**County of San Diego
PRIORITY DEVELOPMENT PROJECT (PDP) SWQMP**

**JAMUL RETAIL CENTER
PERMIT NUMBER:**

Pursuant to the comments provided by the County of San Diego dated September 11, 2018, this report presents a revision to the PDP SWQMP for Jamul Retail Center dated July 10, 2018, prepared by Rick Engineering Company. The following text identifies the review comments issued by the County in italics, followed by Rick Engineering Company's response in bold.

Pursuant to the comments provided by the County of San Diego dated June 15, 2018, this report presents a revision to the report dated March 26, 2018, prepared by Rick Engineering Company. The following text identifies the review comments issued by the County in italics, followed by Rick Engineering Company's response in bold.

JAMUL RETAIL CENTER - BMP x-SECT.

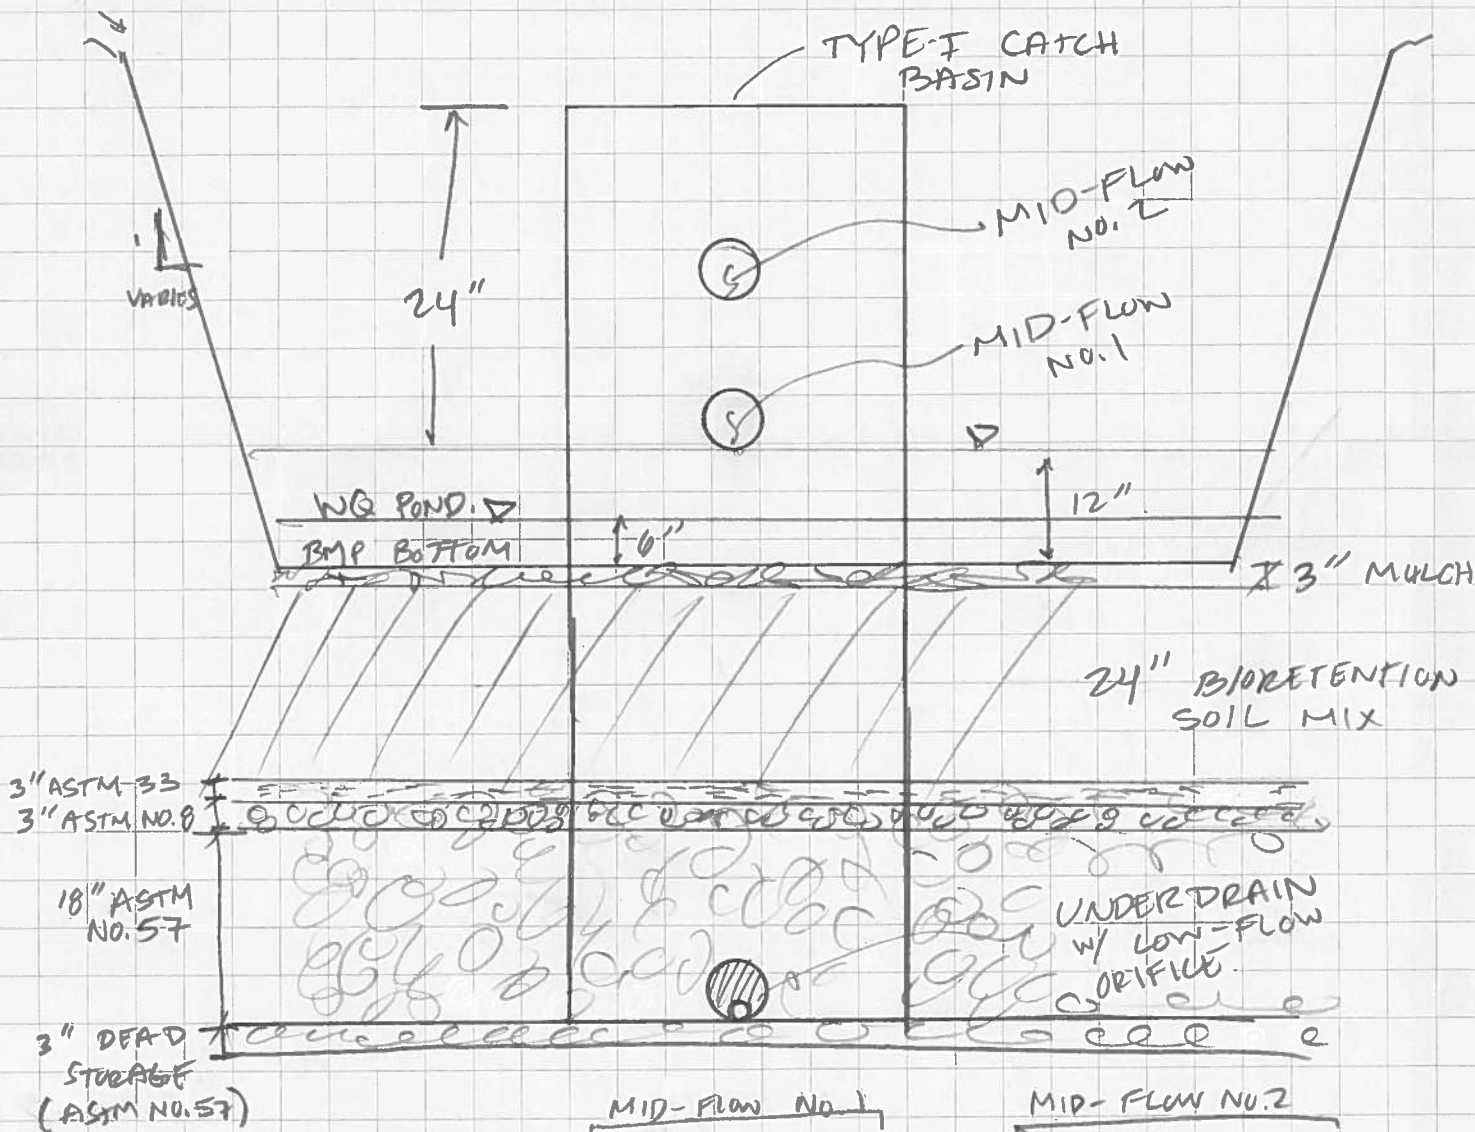
- 4-16. *Revise the detail of the BMP or the table to show the size of the low flow orifice.*

**HYDROMODIFICATION
MANAGEMENT EXHIBIT
FOR
JAMUL RETAIL CENTER
(POST-PROJECT)**

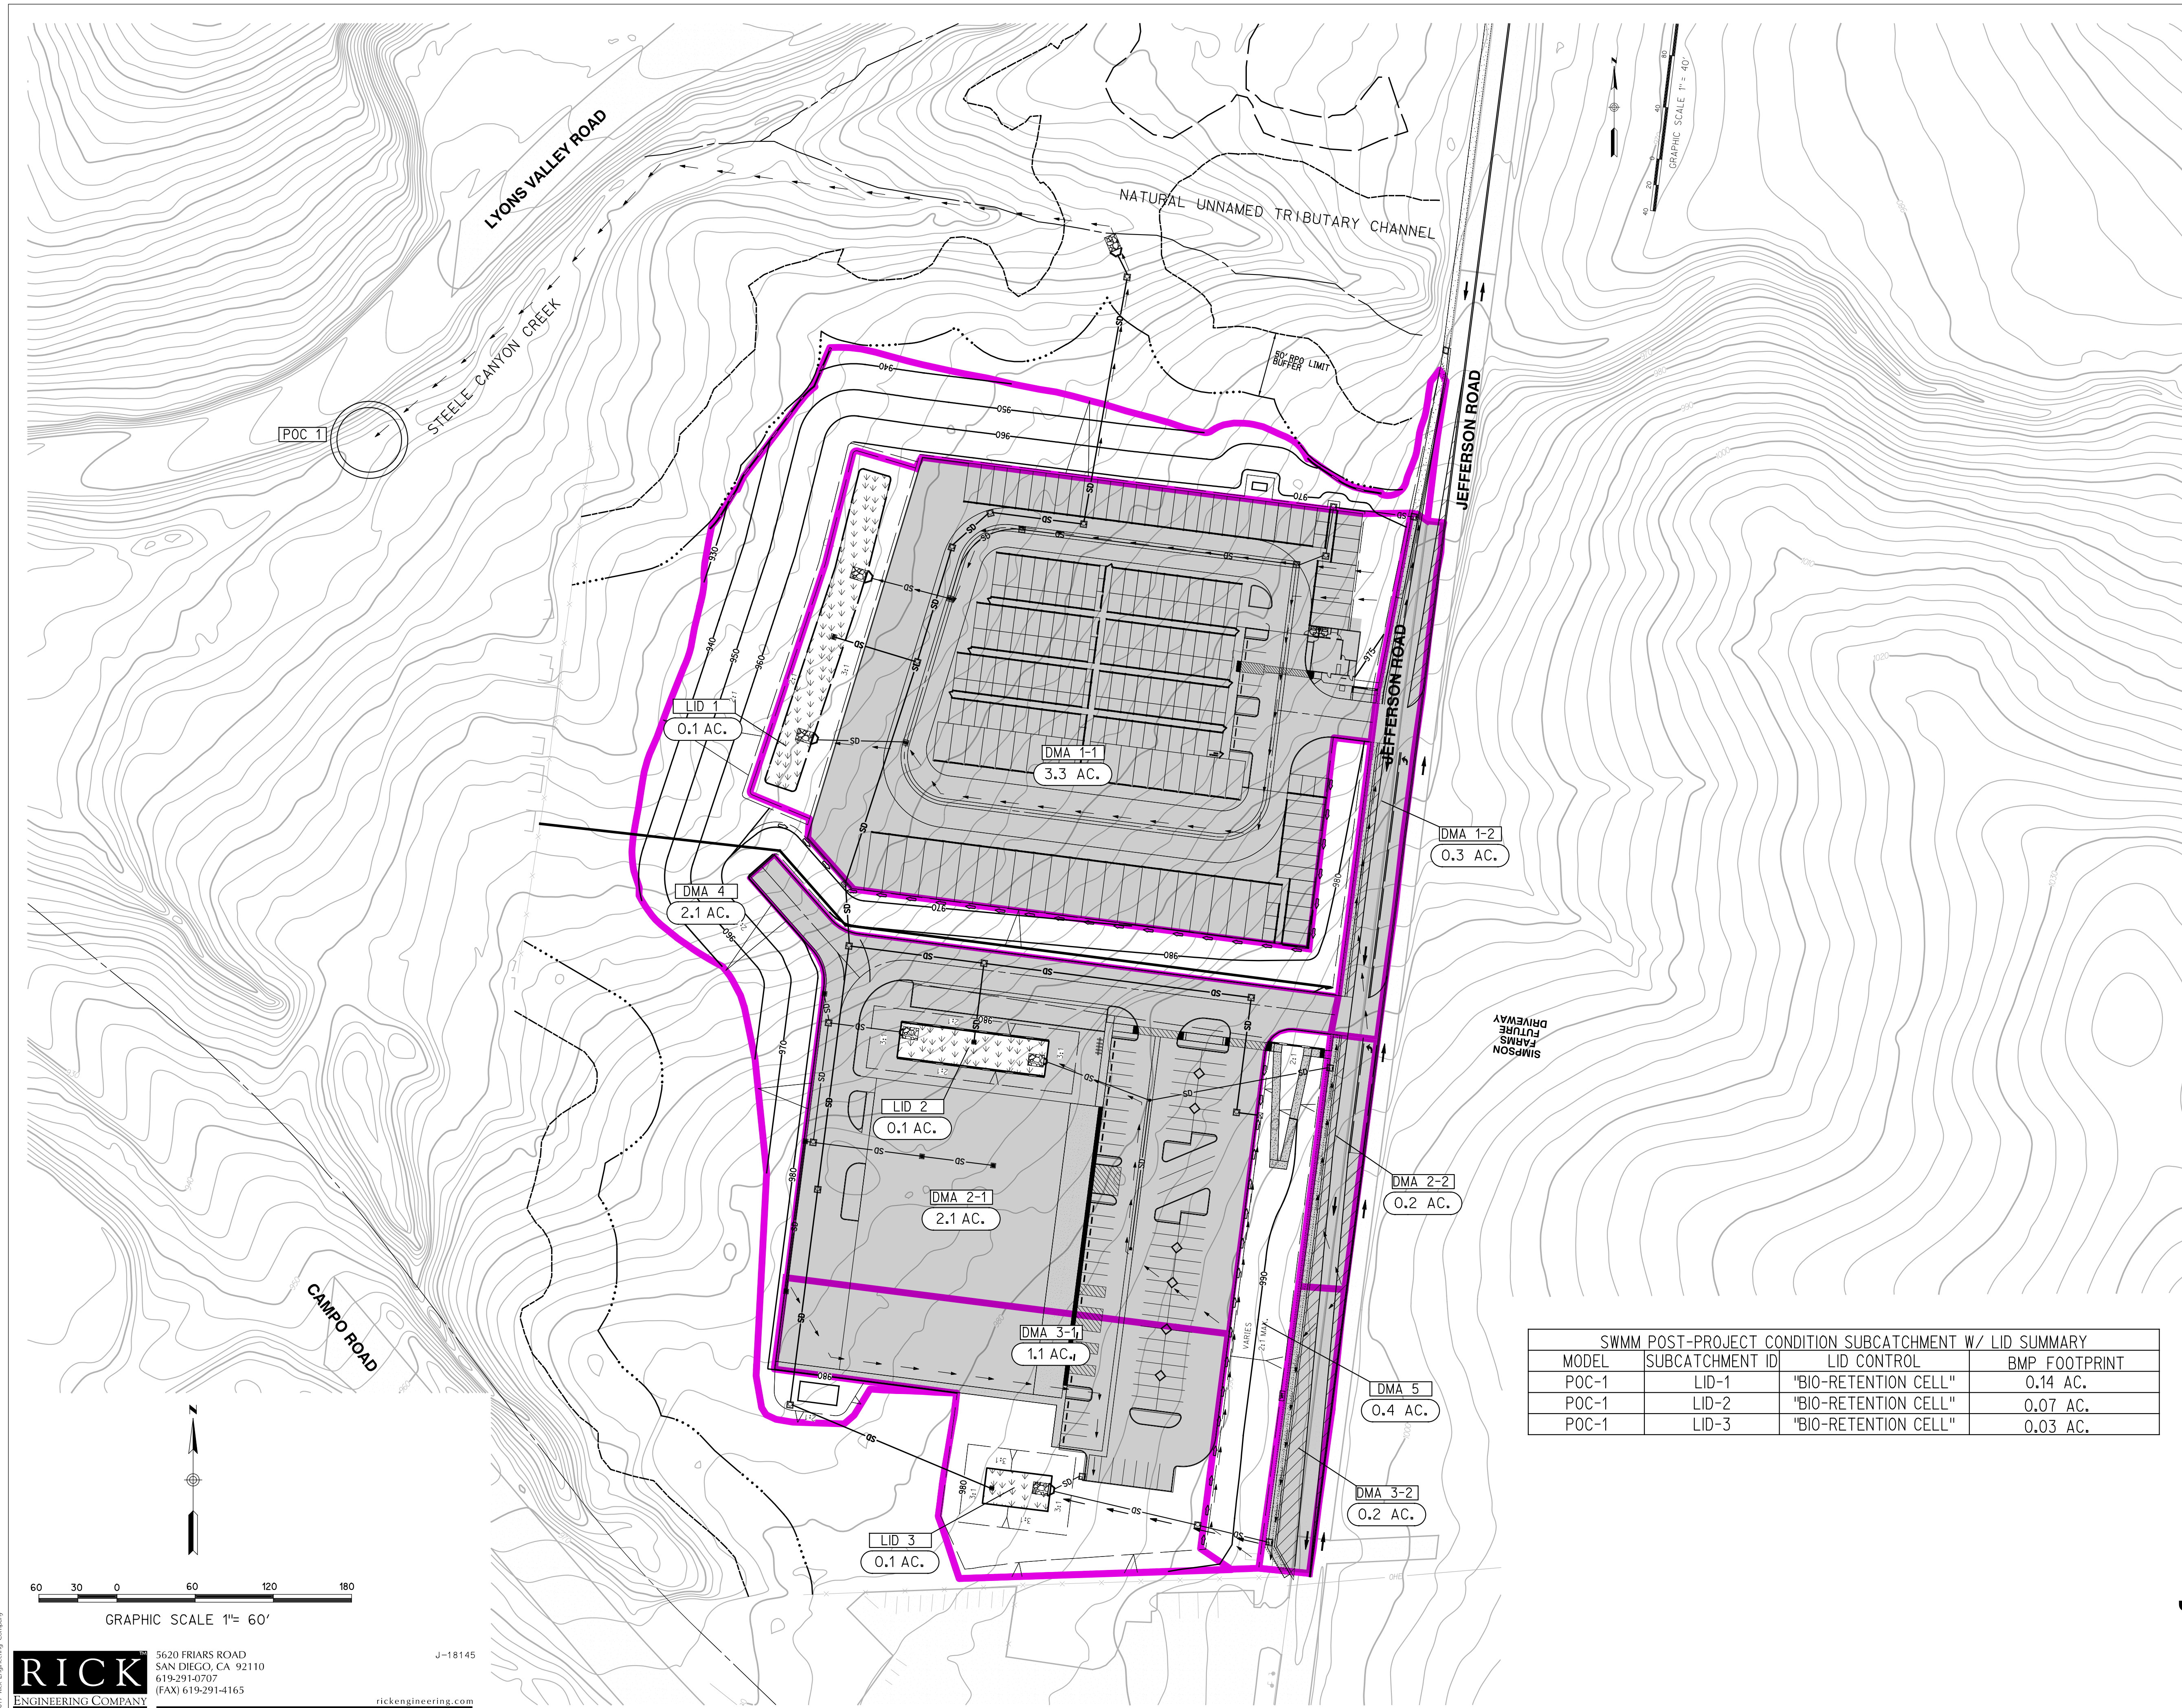
*DMA Exhibit (Attachment 1C/2B):*Clearly show on the plans how the outfall structures for basins 1 will be accessed for maintenance. Please note based on the existing topography, an access road may need to be provided. Any Additional impervious area required for the construction of access roads should be included as part of the stormwater calculation.*

6. *DMA Exhibit (Attachment 1C/2B):*
Clearly label the DMA's that cover the required frontage improvements along Jefferson Road. The DMA may be missing the labels for DMA 2-B and 3-B. Verify and make any necessary changes.

Revise the limits of the DMA and the DCV calculations to include all the required road frontage improvements listed in item 1-2 above.

Provide a table with the breakdown of impervious area for each DMA.

Clearly show on the plans how the outfall structures for basins 1 will be accessed for maintenance. Please note based on the existing topography, an access road may need to be provided. Any additional impervious area required for the construction of access roads should be included as part of the stormwater calculation.

The DMA exhibit has been updated to provide missing DMA labels and to be consistent with the latest site plan. DMA boundaries, DCVs, and the site plan have all been updated accordingly. A table of each DMA with hydrologic characteristics is now provided within the DMA exhibit. Refer to the project's improvement plans for maintenance access.

STREET SECTION A-A: JEFFERSON ROAD
NOT TO SCALE

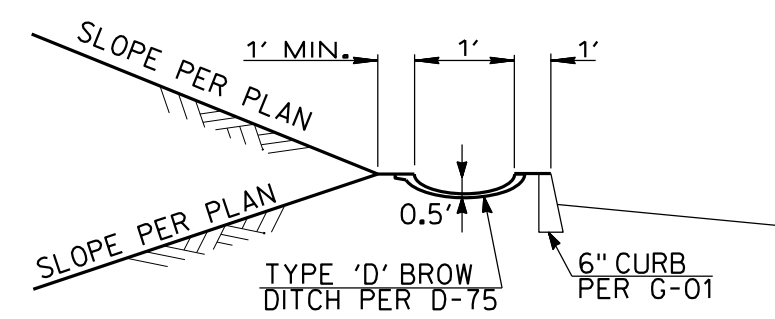
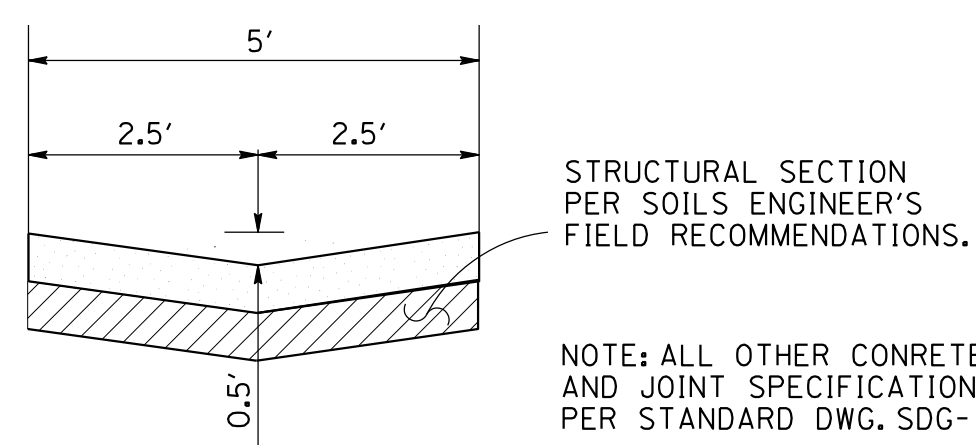
It is unclear how the inlet at the back of the DG pathway will collect drainage from the existing and proposed pavement along Jefferson Road. Based on the typical cross section, the flows drain away from the DG pathway to the gutter. Please clarify the design.

- 4-11. *Step 6.1 (Page 24): Clarify how the Excess treated impervious area is being routed to the proposed BMP's. Based on the location of the inlets and the typical cross section provided, no part of the road widening or existing pavement will be captured by the proposed inlets at the back of the walkway.*

The proposed curb inlets on Jefferson Road will intercept drainage from the existing/proposed pavement along Jefferson Rd. These inlets will only intercept flow from the western half of Jefferson Rd. The eastern half is not being improved as part of this project; therefore, it will not be intercepted by proposed inlets. The DG path drains towards the street. Please refer to the TM Plans, specifically Jefferson Rd Cross Sections A-A and B-B, and the project's Drainage Study for more information regarding drainage characteristics, storm drain, and inlets.

The existing and proposed impervious area on the western half of Jefferson Road slopes towards the proposed inlets. Please refer to the TM Plans, specifically, the proposed grading on Jefferson Rd and Cross Sections A-A and B-B for additional information. Contour intervals have been decreased to 2-ft intervals on the PDP Exhibits for clarity. Refer to Response to Comments 4-4 and 4-5 for updated information regarding BMP design.

TYPICAL BMP CROSS SECTION
NOT TO SCALE

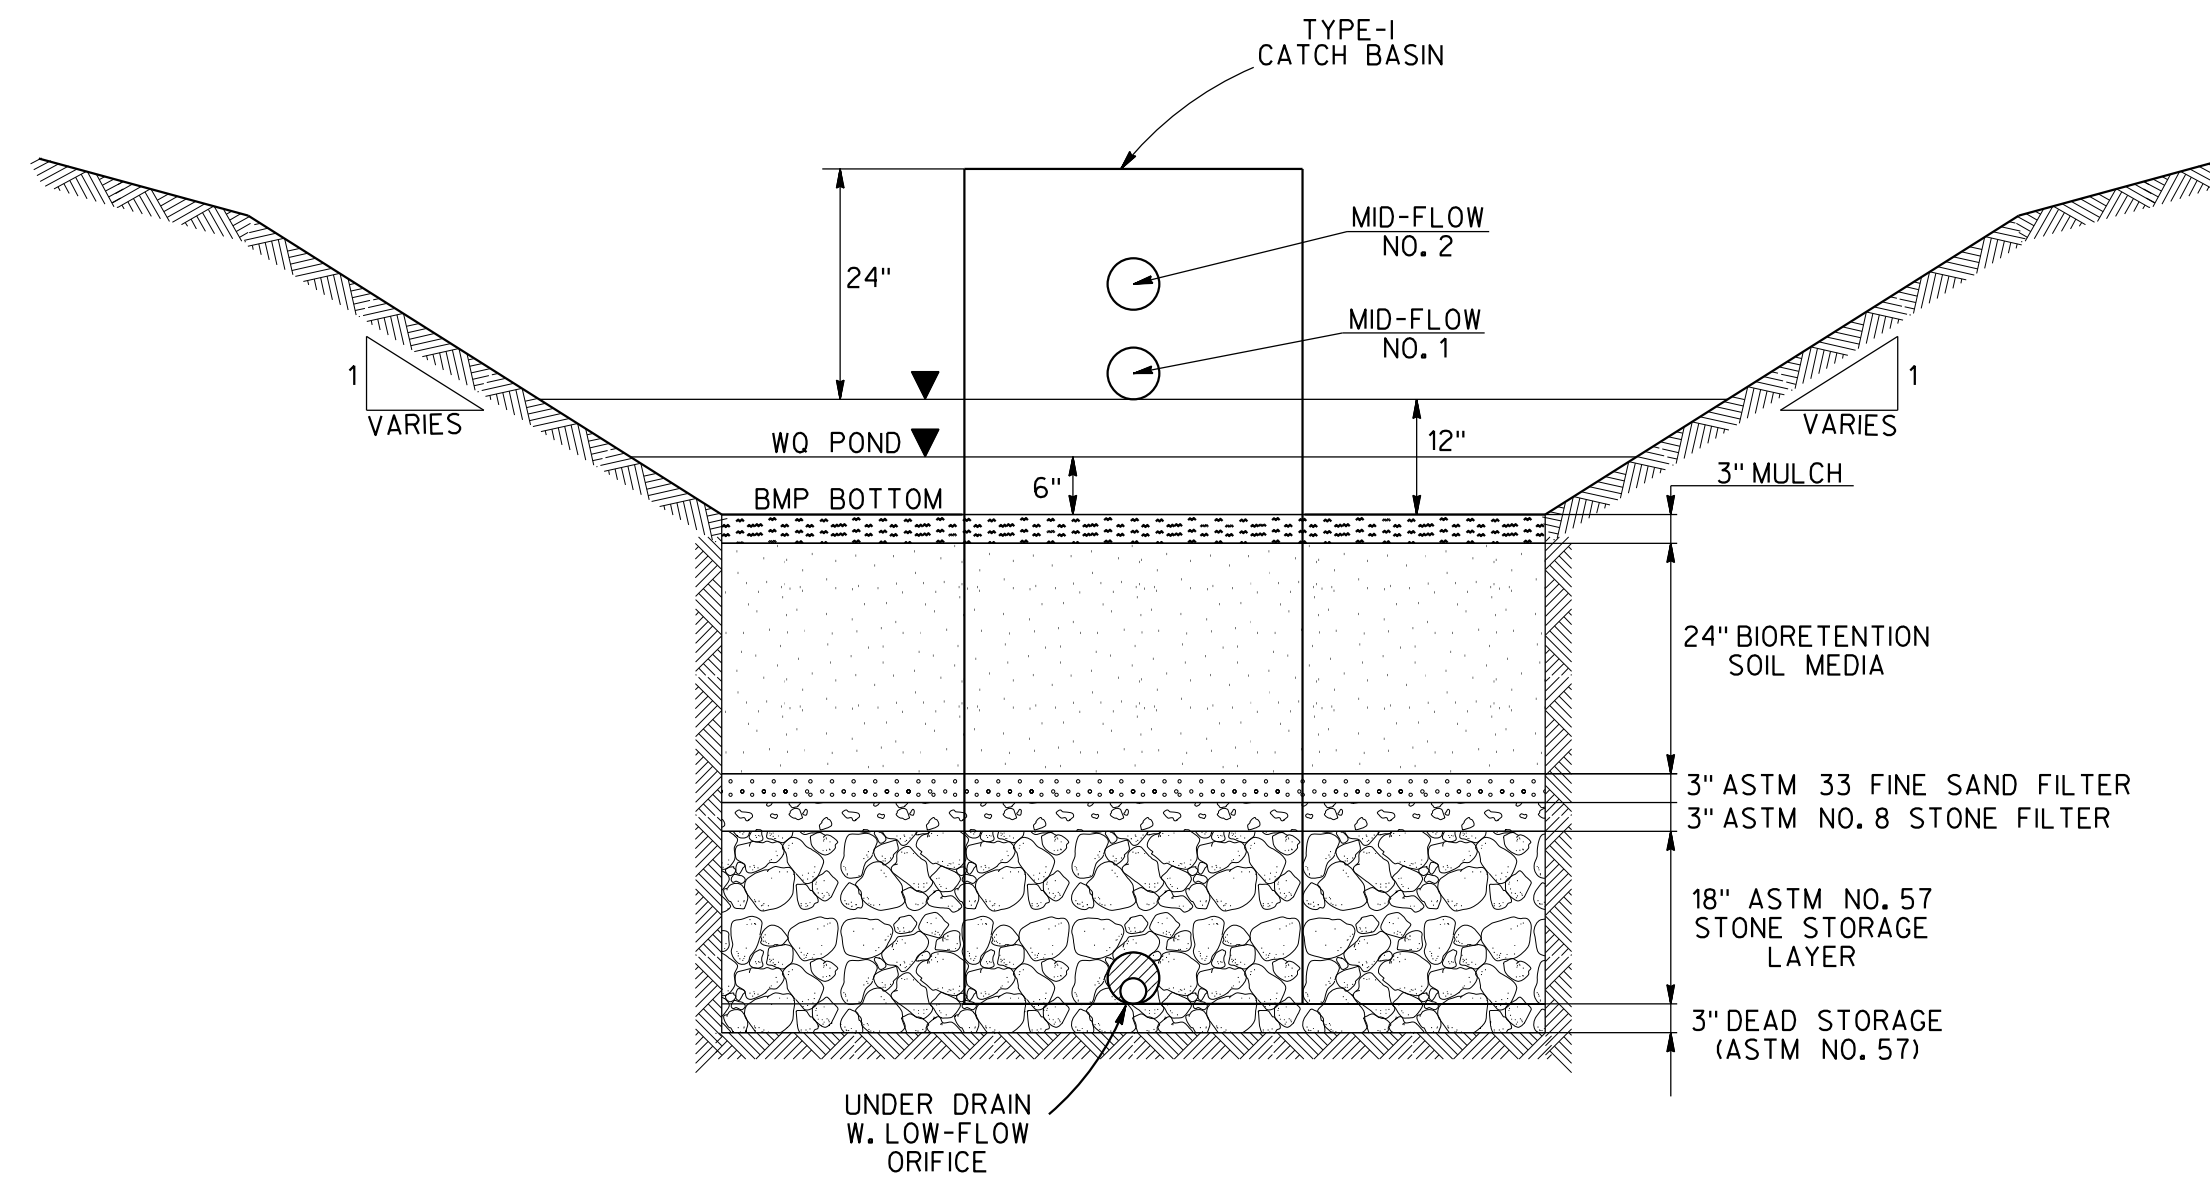
**Ensure the properties of basins between worksheet B5-1 and SWMM model are consistent. For example, SWMM model and the basins details show surface ponding of 12" for basins 1 and 2 but worksheet B5-1 shows surface ponding of 6" for these basins.*

8. *Ensure the properties of basins between SWMM model, Worksheet B5-1, and the provided BMP detail are consistent. For example, BMP 3 is modeled with 12" ponding depth in SWMM which is not constant with Worksheet B5-1 and the BMP detail provided. Verify and make any necessary changes.*

The proposed BMPs only utilize 6-inches of ponding for water quality purposes (i.e., the required DCV is provided with the sub-surface volume and only 6-inches of ponding). The additional 6-inches of ponding above the WQ ponding depth is used for HMP purposes (i.e., to provide detention of the low-flow events). Due to the HMP low-flow threshold and required volume, the low-flow orifice results in a draw-down time greater than 24-hrs (approximately 33 hrs). BMP 1 has more than enough static storage to hold the DCV for DMA 1 and provides a footprint in excess of 3% of the effective impervious area. The drawdown time for BMP 1 will be finalized during the final engineering phase, and if it is in excess of 24-hrs it will be coordinated with the County and the project's Landscape Architect. Narrative regarding this comment has been added to Step 6.1 for additional clarification.

The proposed BMPs only utilize 6-inches of ponding for water quality purposes. The additional 6-inches of ponding above the WQ ponding depth is used for HMP purposes (i.e., to provide detention of the low-flow events). WQ calculations are based on the 6-inches of ponding and HMP calculations are based on 12-inches of ponding. The SWMM models have been updated to be consistent with the latest site plan; however, continue to use 12-inches of ponding prior to the first mid-flow orifice.
